# Addendum Addenda

No./No  2
-----------------

Project Description / Description de projet <b>U-61 Asbestos Containing Fireproofing Removal and Cladding Replacement</b>		
Project No./No de projet <b>5698</b>	Departmental Representative / représentant ministériel <b>Benoit Huot</b>	Date <b>15 Dec 2020</b>
Solicitation No./N° de sollicitation <b>20-58082</b>		
Notice: This addendum shall form part of the tender documents and all conditions shall apply and be read in conjunction with the original plans and specifications.		
Nota: Cet addenda fait partie intégrale des dossiers d'appel; toutes les conditions énoncées doivent être lues et appliquées en conjonction avec les plans et les devis originaux.

PROJECT: PROJECT NO. = 5698  
BUILDING U-61 (UPLANDS CAMPUS)  
**U-61 EXTERIOR UPGRADES OF UPPER TARMAC CLADDING COMPLETE WITH FIREPROOFING ABATEMENT**

15 PARTIAL SOUTH ELEVATION  
 A08 1:75

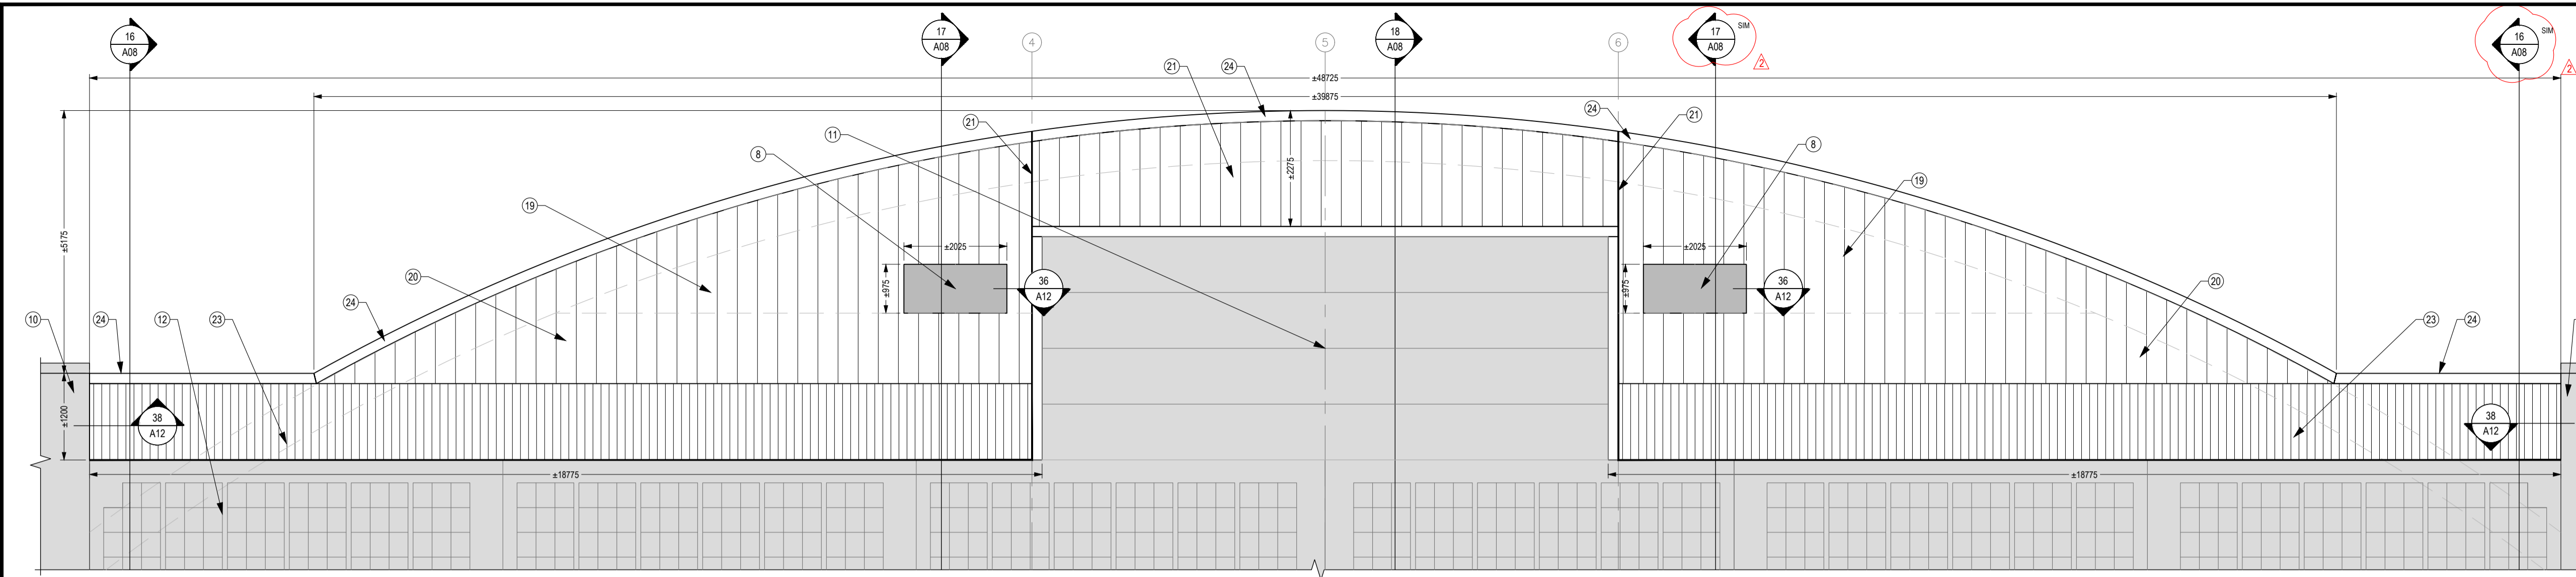
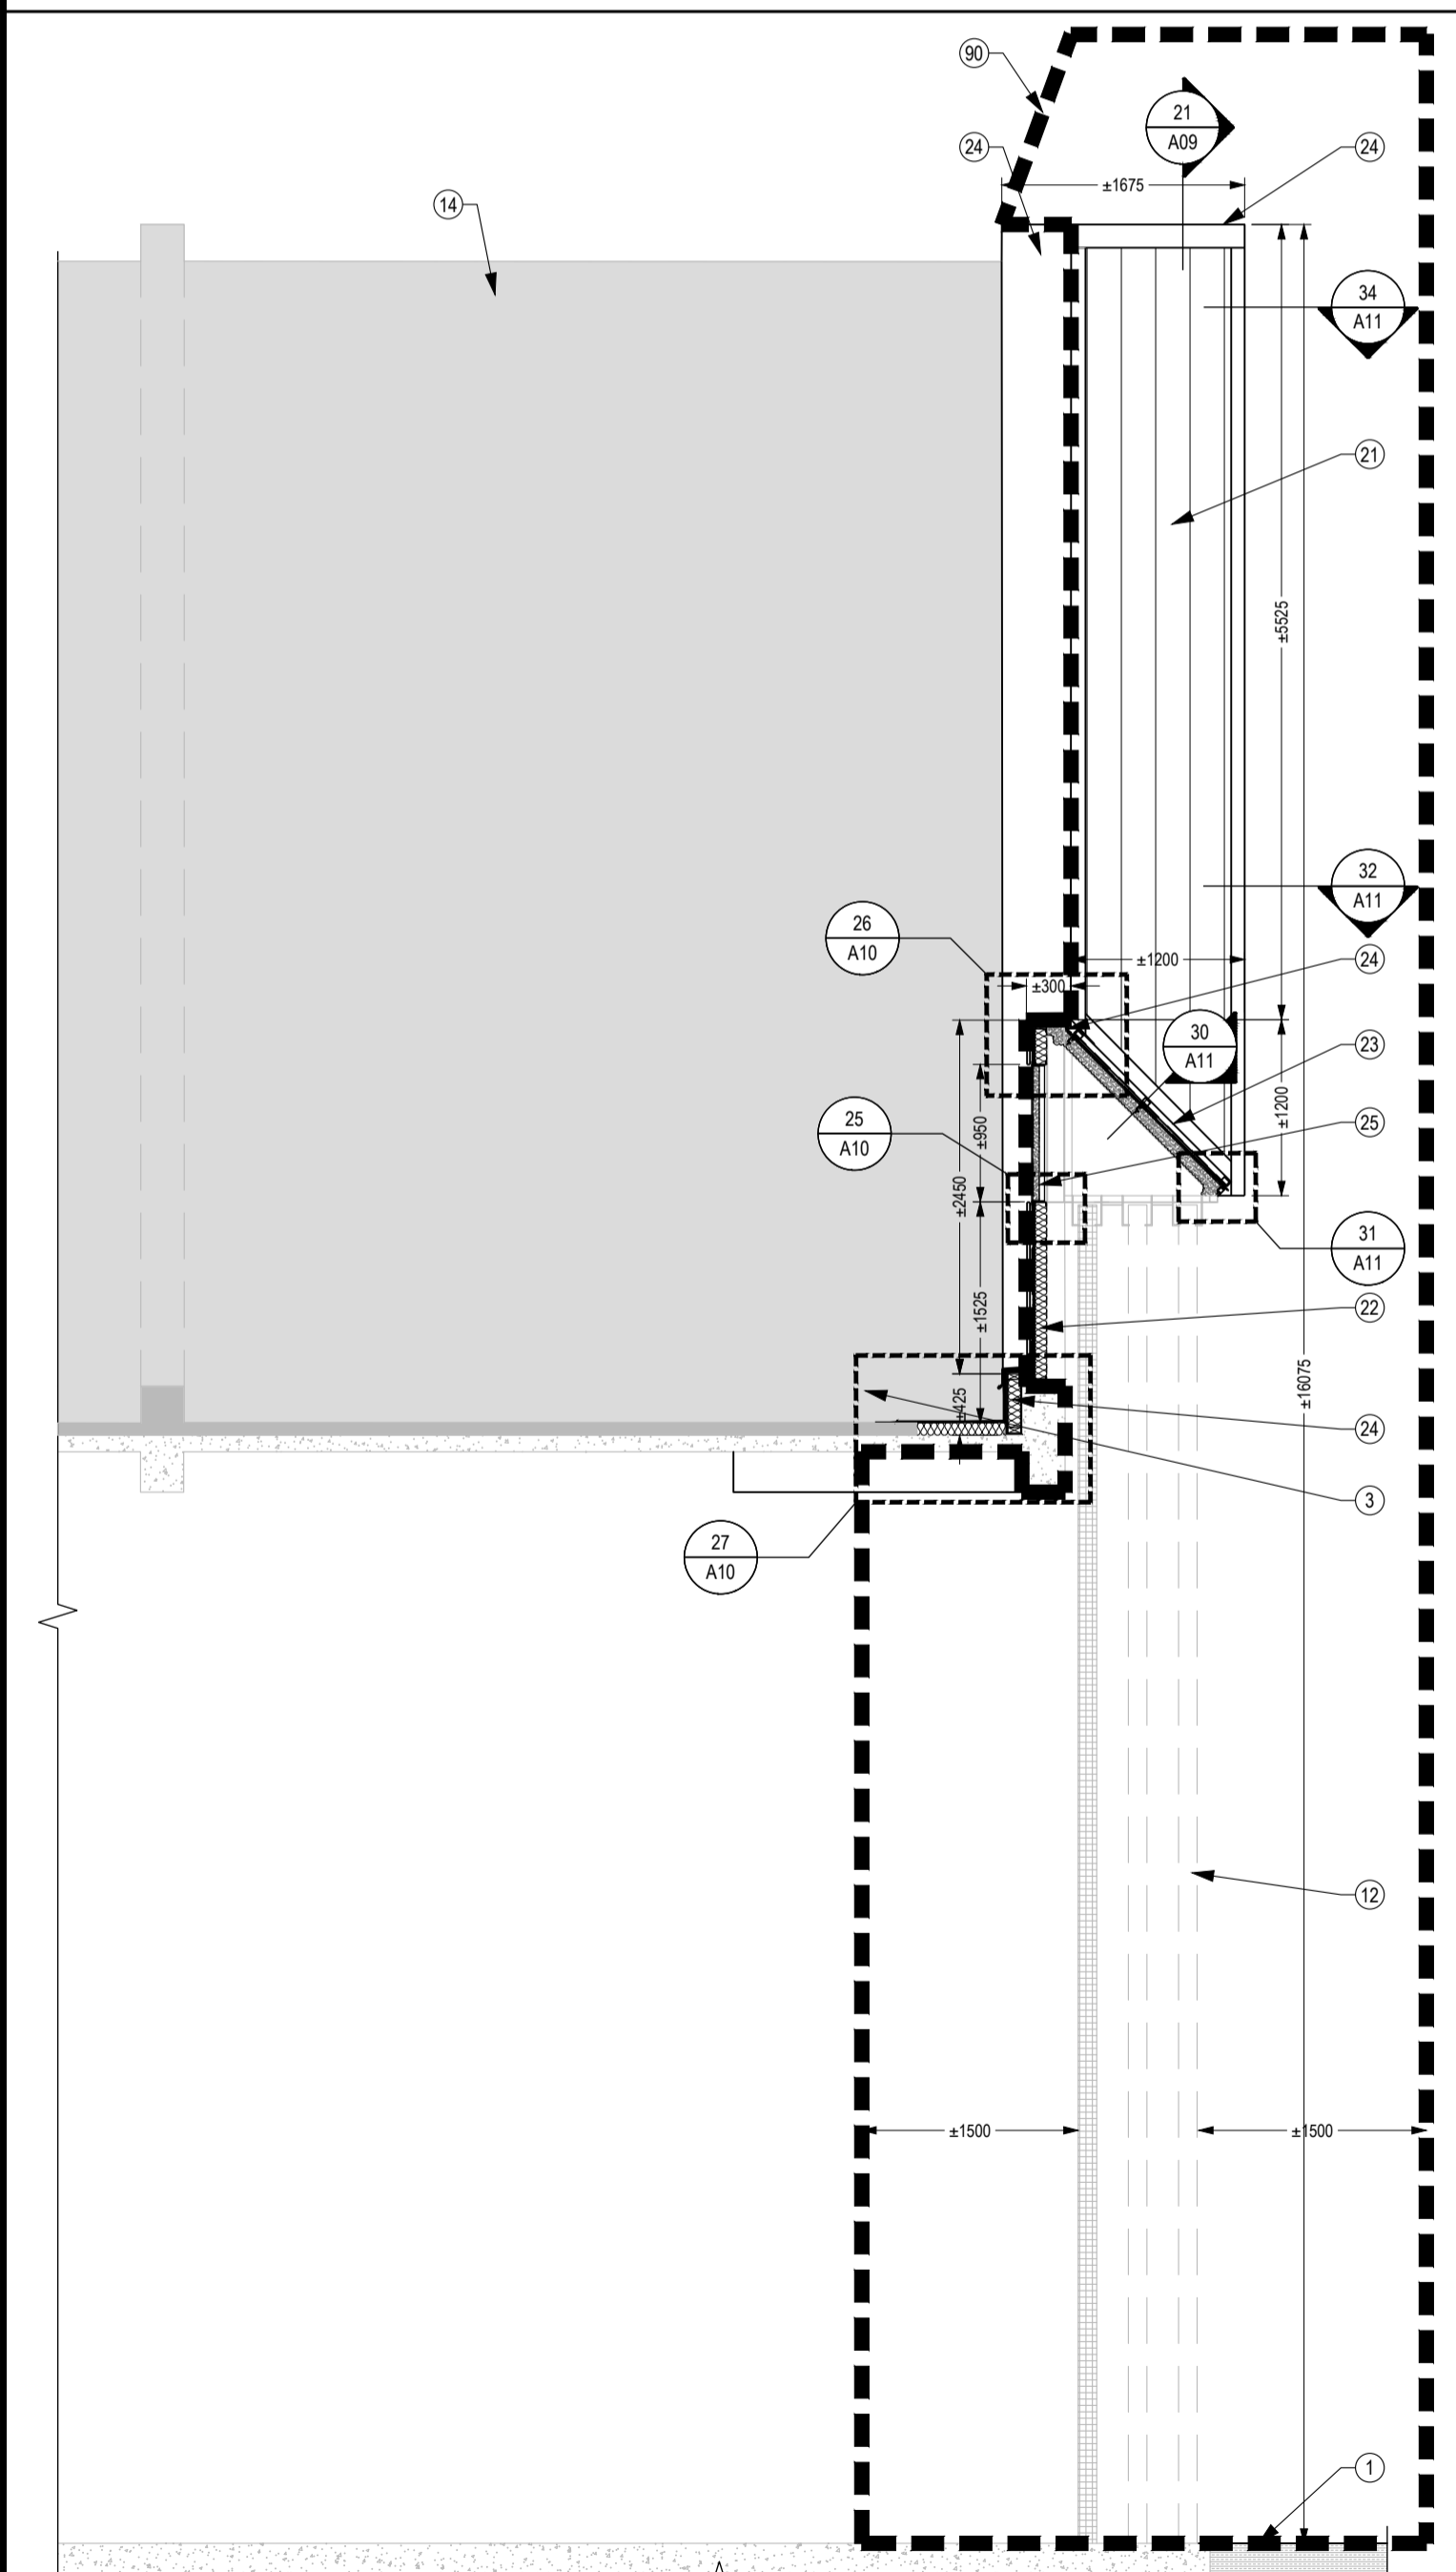
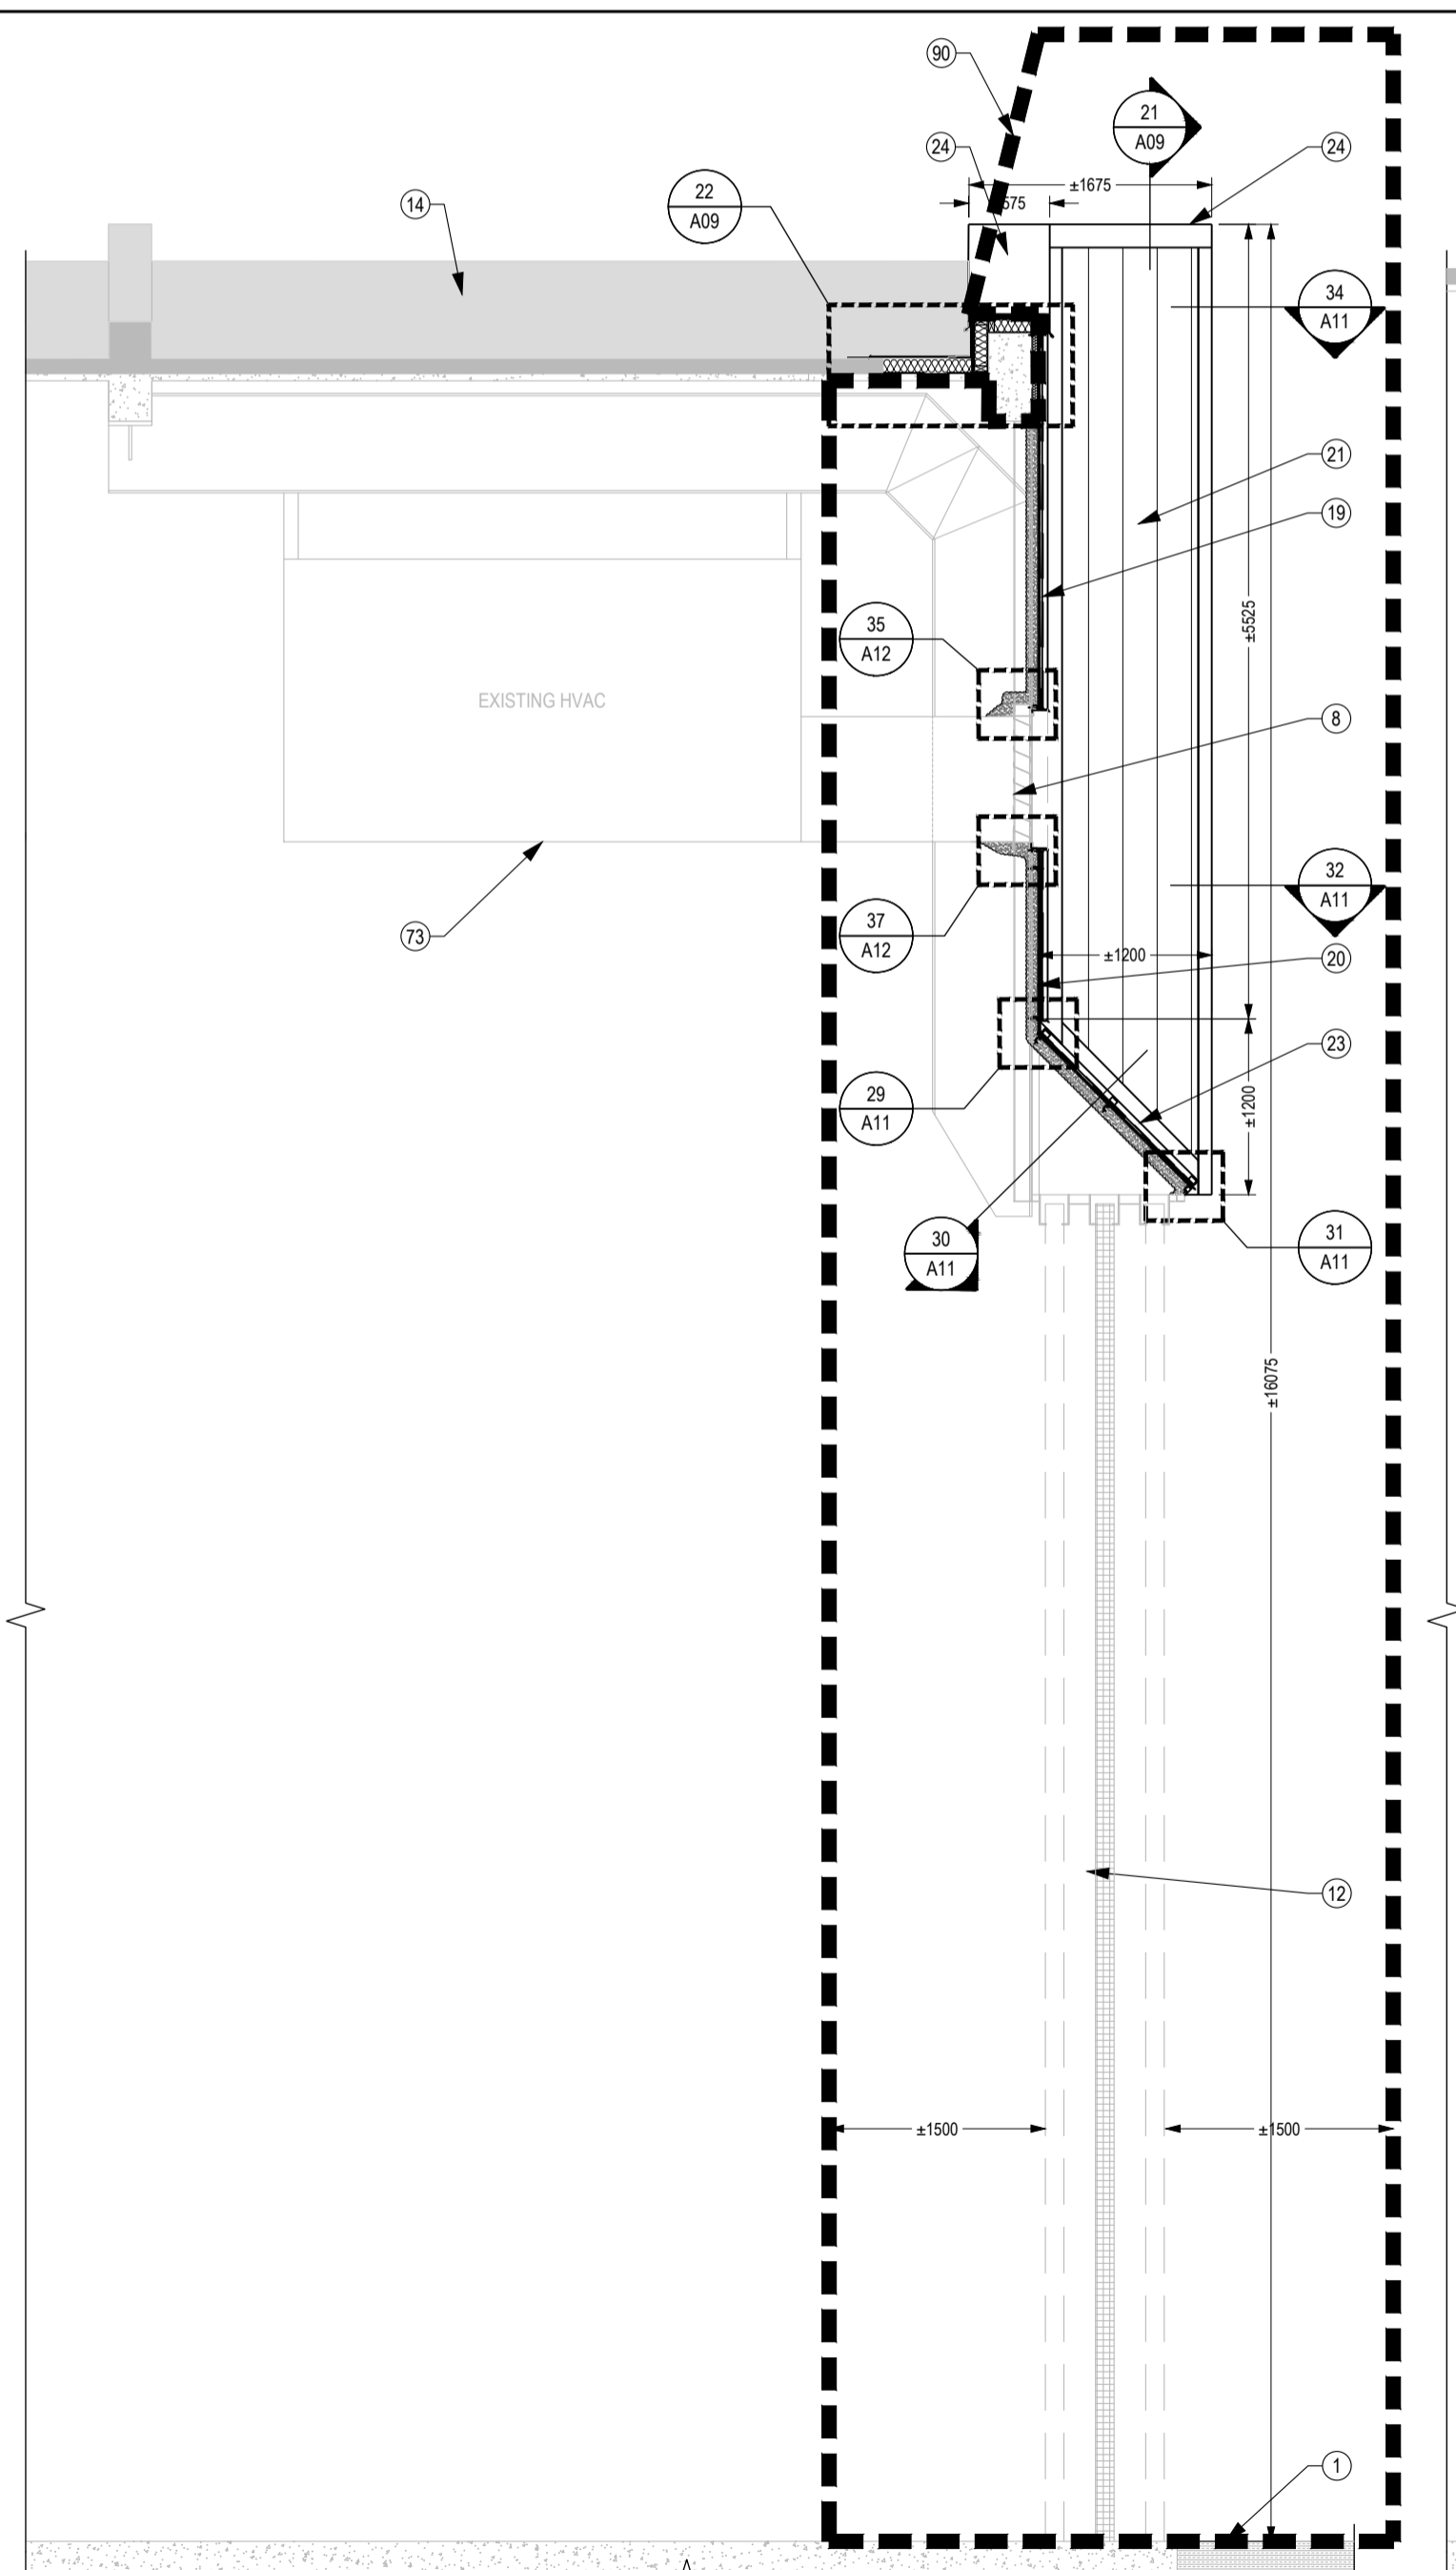
Architectural detail 38A12 notes relet cut into existing concrete wall at standing Seam roof. Cross sections 16 & 17 A08 show steel cladding on concrete walls. Please Clarify if cladding to be installed over wall flashing /reglet tie in as not show on detail 38.

There is no metal cladding to be installed over the concrete walls. Sections 16 & 17 cut lines on Detail 15/A08 have been revised. Sections 16 & 17 show the cladding present on the sides of the central portion of the hanger.
